RESPONSE LETTER

**RE: Living Water Express Car Wash, Smoky Hill Crossings
Pre-submittal Meeting (# 1448451)**
Smoky Hill Crossings (Smoky Hill RD and Gun Club RD)
Lot 1

STAFF COMMENTS - PRE-APPLICATION MEETING

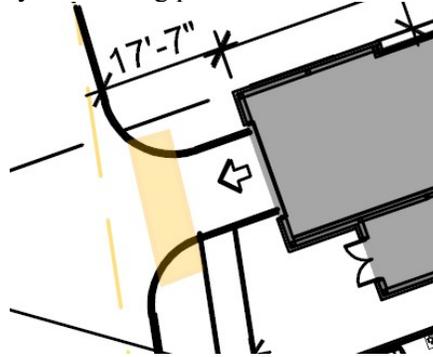
- ▶ Consider widening out the radius of the turn prior to entry into the wash (provide turning template for a standard large SUV & truck).

Response: An auto-turn design has been run to verify SUV and trucks can make the entry turn. However, the entry turn has been revised to allow more clearance for a turn.
